CONTRACT CHANGE ORDER NO. 228 S1
SHEET 2 OF 14

CLOSURE BOX FOR BIKEPATH BOTTOM PLATE

SAN FRANCISCO OAKLAND BAY BRIDGE
EAST SPAN SEISMIC SAFETY PROJECT
SELF-ANCHORED SUSPENSION BRIDGE
(SUPERSTRUCTURE & TOWER)

BIKEPATH FRAMING DETAILS NO. 7

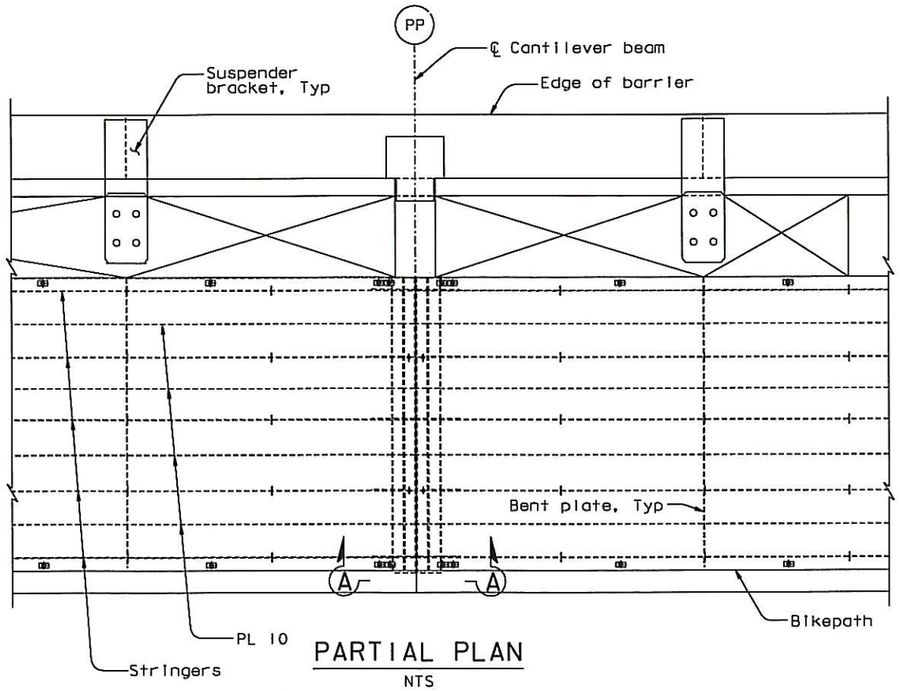
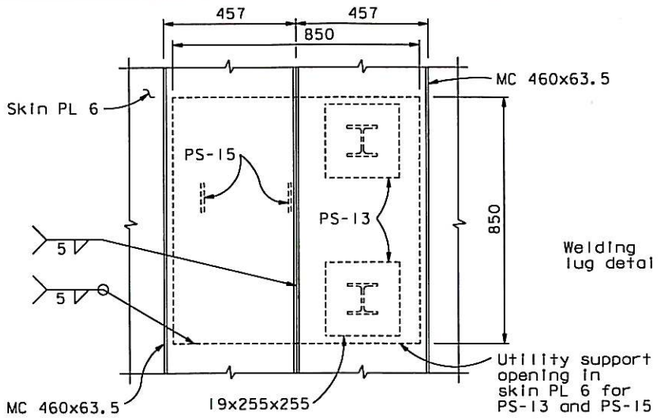
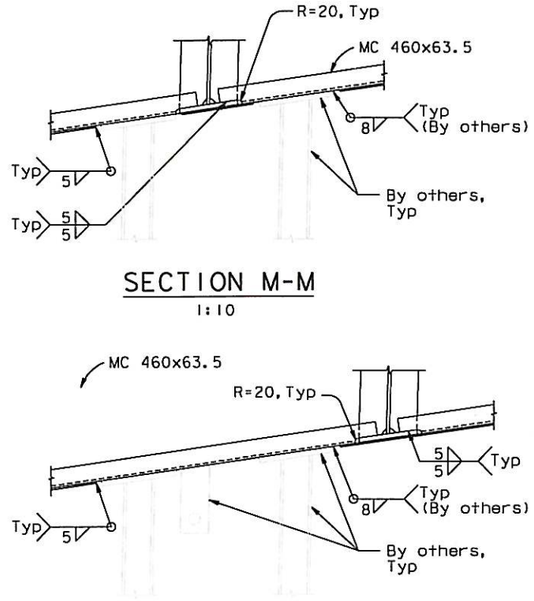
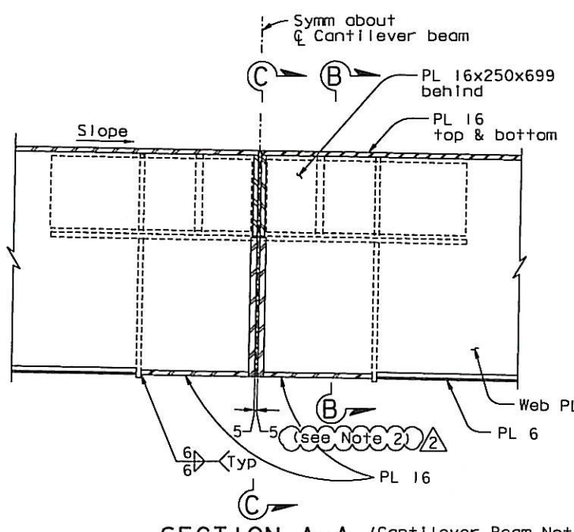
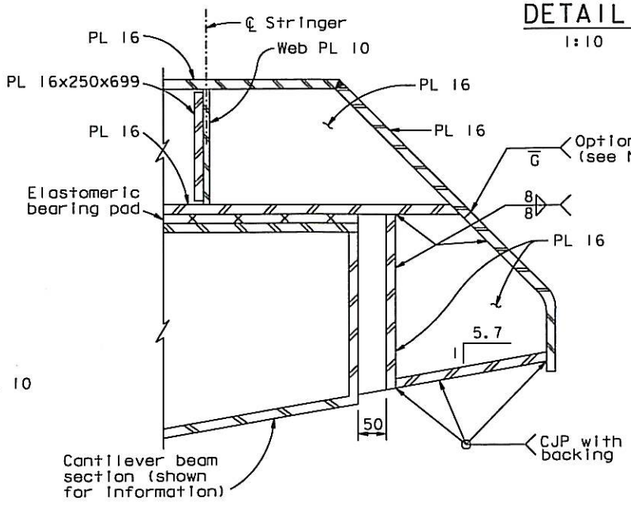
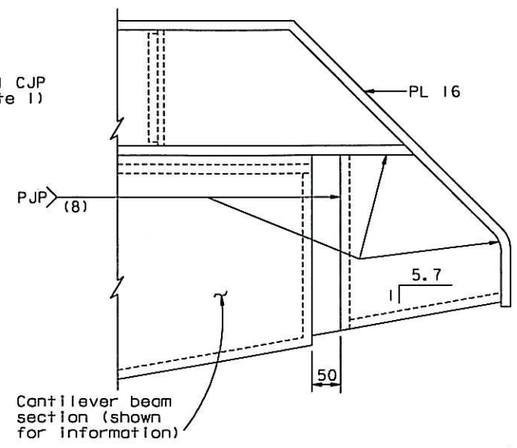
1. For Bikepath segments that have been fabricated without a "Closure Box", a CJP shall be used.
2. Tolerance on the gap between bikepath panels shall be (+20 mm, -0 mm).

MARK	DATE	REVISIONS	BY	CH'D	CCO#
2	08/17/12	BIKEPATH LEVELING	AB	TH	228S1
1	08/20/10	BIKEPATH DETAILS	AB	TH	99
0	07/24/09	BIKEPATH DETAILS	CC	TH	99

BIKEPATH DETAILS NO. 23

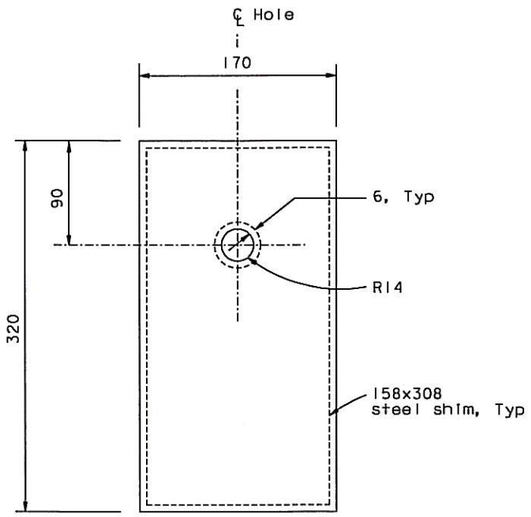
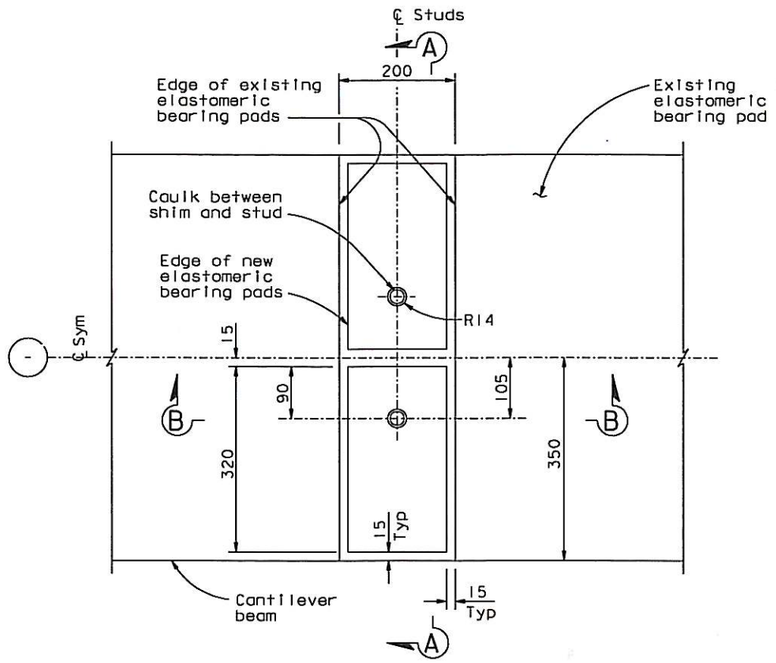
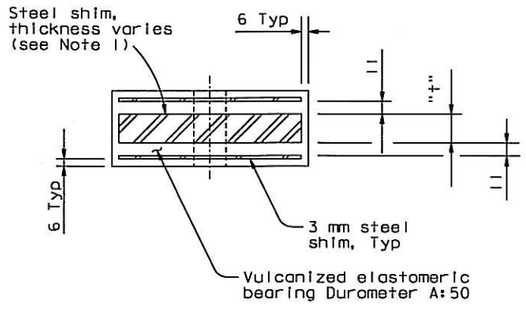
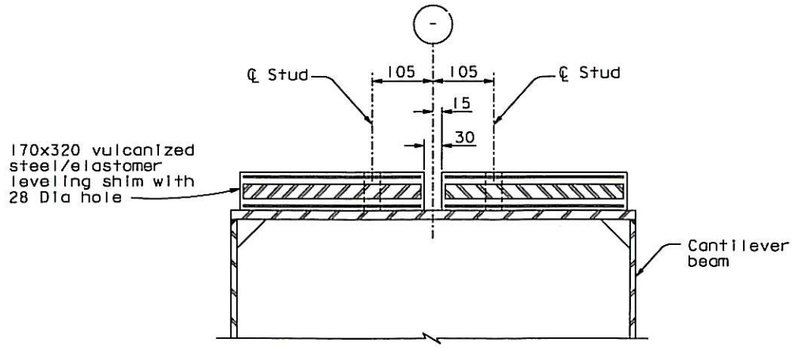
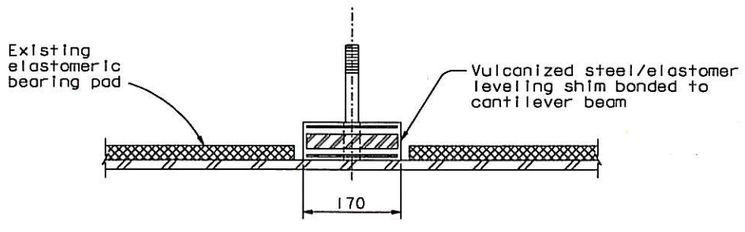
MARK	DATE	REVISIONS	BY	CH'D	CCO#
6	08/17/12	BIKEPATH LEVELING	AB	TH	22851

1. For steel shim thickness "t", see "Bikepath Details No.24" sheet.
